**RESOLUTION MEPC.261(68)**  
**(adopted on 15 May 2015)**

**AMENDMENTS TO THE 2014 GUIDELINES ON SURVEY AND CERTIFICATION  
OF THE ENERGY EFFICIENCY DESIGN INDEX (EEDI)**  
**(RESOLUTION MEPC.254(67))**

**AMENDMENTS TO THE 2014 GUIDELINES ON SURVEY AND CERTIFICATION  
OF THE ENERGY EFFICIENCY DESIGN INDEX (EEDI)  
(RESOLUTION MEPC.254(67))**

**Figure 2: An example of scheme of conversion from trial condition to EEDI condition at EEDI power**

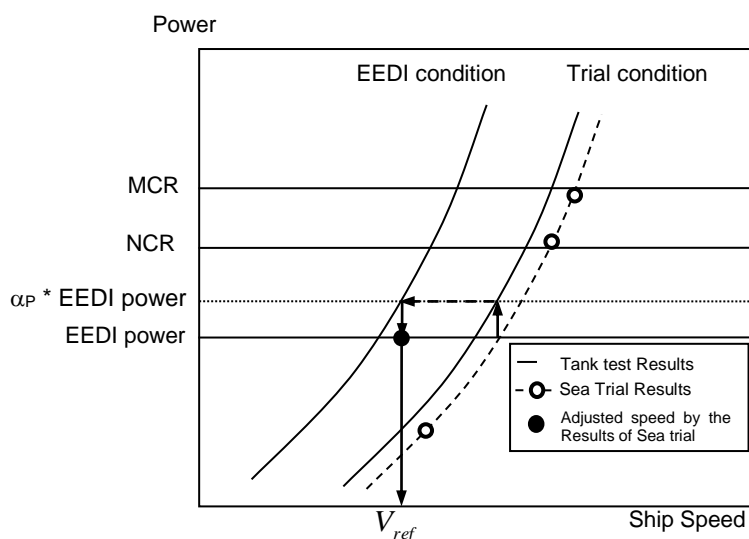
4.3.9 The submitter should compare the power curves obtained as a result of the sea trial and the estimated power curves at the design stage. In case differences are observed, the attained EEDI should be recalculated, as necessary, in accordance with the following:

- .2 for ships for which sea trial cannot be conducted under the condition as specified in paragraph 2.2 of the EEDI Calculation Guidelines: if the measured ship speed at the power of the main engine as specified in paragraph 2.5 of the EEDI Calculation Guidelines at the sea trial conditions is different from the expected ship speed on the power curve at the corresponding condition, the shipbuilder should recalculate the attained EEDI by adjusting ship speed under the condition as specified in paragraph 2.2 of the EEDI Calculation Guidelines by an appropriate correction method that is agreed by the verifier.

An example of scheme of conversion from trial condition to EEDI condition at EEDI power is given as follows:

$V_{ref}$  is obtained from the results of the sea trials at trial condition using the speed-power curves predicted by the tank tests. The tank tests shall be carried out at both draughts: trial condition corresponding to that of the S/P trials and EEDI condition. For trial conditions the power ratio  $\alpha_P$  between model test prediction and sea trial result is calculated for constant ship speed. Ship speed from model test prediction for EEDI condition at EEDI power multiplied with  $\alpha_P$  is  $V_{ref}$ .

Figure 2 shows an example of scheme of the conversion to derive the resulting ship speed at EEDI condition ( $V_{ref}$ ) at EEDI power.

**Note:** Further consideration would be necessary for speed adjustment methodology in paragraph 4.3.9.2 of these guidelines. One of the concerns relates to a possible situation where the power curve for sea trial condition is estimated in an excessively conservative manner (i.e. power curve is shifted in a leftward direction) with the intention to get an upward adjustment of the ship speed by making the measured ship speed at sea trial easily exceed the lower-estimated speed for sea trial condition at design stage."
